Duane Arnold Energy Center

NG-07-0932
10 CFR 50.90

Application for Technical Specification Change to Add Surveillance for River Depth
Affected Technical Specification: Section 3.7.2

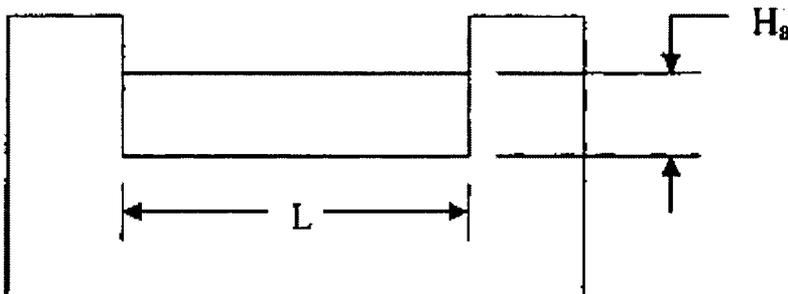
Figure 1 is an aerial view of the Cedar River, showing the location of the Intake Structure and Spur Dikes. Figure 2 is a cut-away of the Intake Structure looking to the north. The Intake Structure foundation is constructed on bedrock. This figure shows how river level and depth in front of the Intake Structure impact flow into the Intake Structure. The Intake Structure consists of two openings that act as rectangular weirs as depicted in the following figure.

To determine a minimum depth requirement, a flow requirement equal to pump run out conditions for the RWS pumps was used, i.e., 17.60 cfs. The length of the rectangular weir, L , is 13.5 feet. Assuming only one weir is available; a depth H_a of 6.48 inches is required to obtain 17.60 cfs of flow. The proposed Surveillance Requirement ensures margin to the minimum flow by specifying a depth of 12 inches or greater at the Intake Structure.

Figure 1

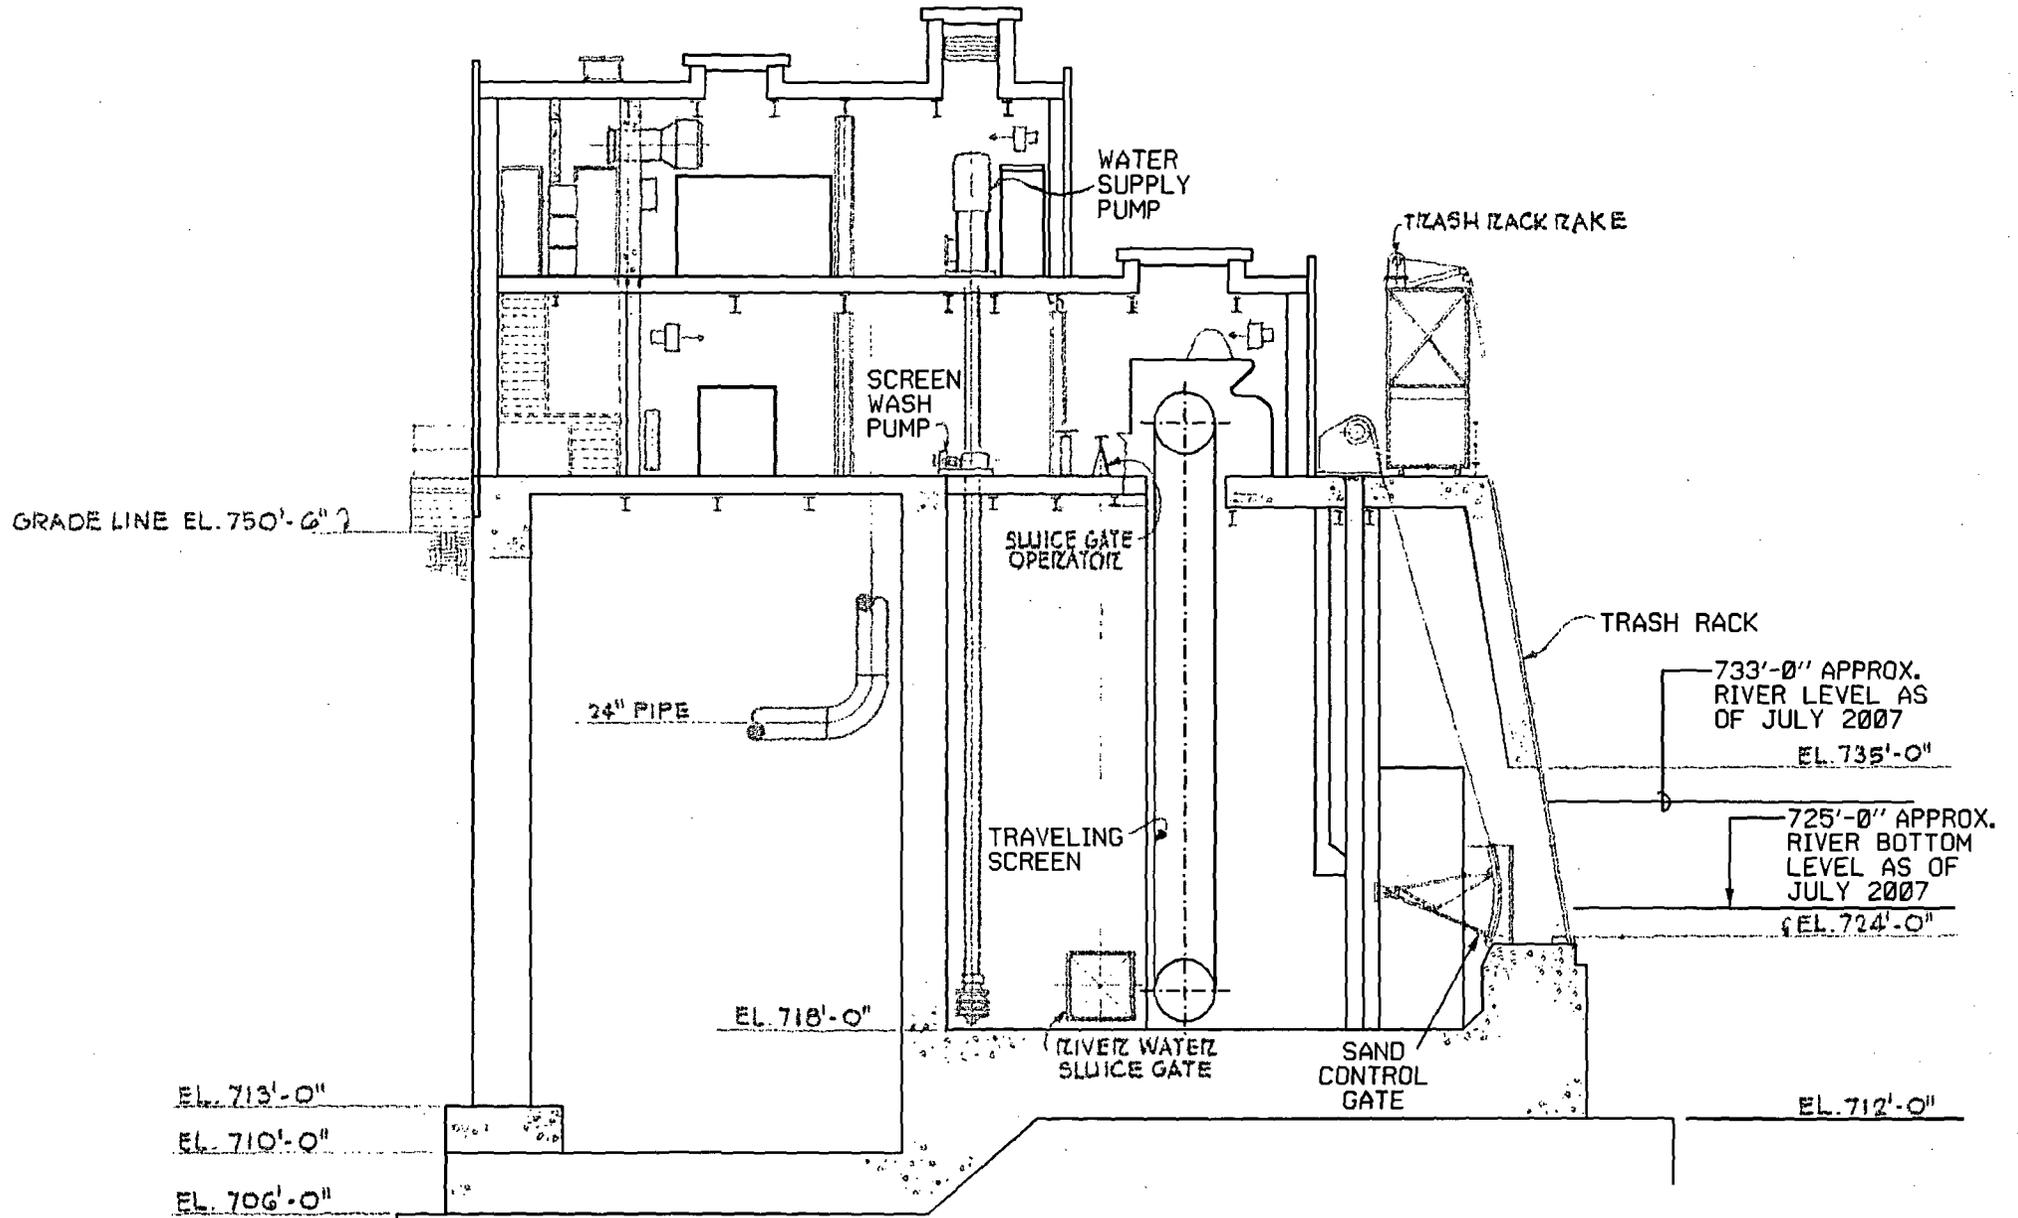
In 2006, FPL Energy Duane Arnold installed Spur Dikes upstream of the Intake Structure on the riverbank opposite to the Intake Structure. The Spur Dikes are placed on the east riverbank, upstream of the Intake Structure, to direct the Cedar River flow tangentially toward and immediately along the face of the Intake Structure. The purpose of these Spur Dikes is to quicken the river flow past the Intake Structure to minimize the sediment movement toward the Intake Structure. The spur dikes are designed to alter the river flow into a new configuration over time. As water travels past the spur dikes, sediment is deposited in between the dikes causing the riverbank to build-up. The placement of the spur dikes is intended to straighten the riverbank to the 1980 river bounds. This would direct river flow straight past the Intake Structure, narrow the river channel, and create faster flows past the Intake Structure thereby sweeping sediment away.
